ROIG

September 19, 2006

Addendum to Work Plan for Additional Soil and Groundwater Investigation RE: And Site Conceptual Model with Preferential Pathway Study 3744 Depot Road, Hayward, CA

Attachments Revised Figure 4 Revised Table 1 –Rationale for Locations of Borings

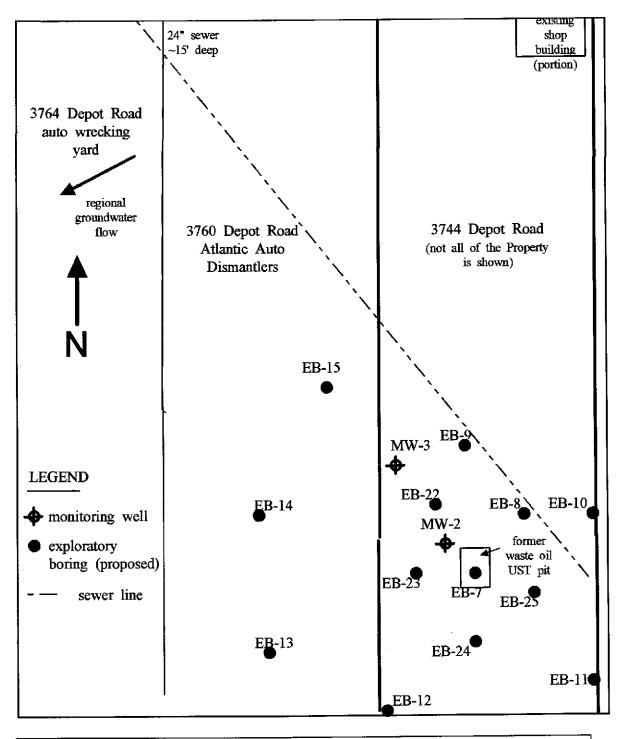
Based on our telephone discussion on September 13, 2006, PIERS has prepared this addendum to our "Work Plan for Additional Soil and Groundwater Investigation And Site Conceptual Model with Preferential Pathway Study" dated July 2004, for the above-referenced site. This addendum proposes the addition of soil analyses for the previously proposed exploratory soil borings in the southern portion of the site around the former waste oil tank pit (EB-8 through EB-15). Also proposed are additional borings EB-22 through EB-25 that are located closer to the former waste oil tank pit than originally denoted. The purpose of these borings is to provide additional lateral delineation of hydrocarbons in soil and water in the vicinity of the former waste oil tank pit. The locations of the additional proposed borings are shown on revised Figure 4, see attached.

At each of the boring locations (EB-8 through EB-15 and EB-22 through EB-25), soil samples will be collected at approximately five-foot intervals, at changes in lithology, and at signs of obvious contamination, until the first encountered groundwater. As in the previous borings, it is anticipated that one soil sample will be collected at the capillary fringe, approximately 11.5 feet below grade. As stated in the work plan, the soil borings will be completed to the depth of the deepest impacted zone identified at the source. If other water-bearing zones are encountered, methods will be employed to reduce the potential for cross-contamination during drilling. "Grab" groundwater samples will also be collected. A photo-ionization detector (PID) will be utilized during drilling to determine if any soil is impacted.

If no contamination is observed in the field, including with the PID, the shallow soil samples from the most distant borings (EB10 through EB15) will be placed on hold, and only analyzed if the analytical results of the closer borings indicate that the extent of shallow contamination remains undefined. The capillary fringe soil samples for all of these borings will be analyzed.
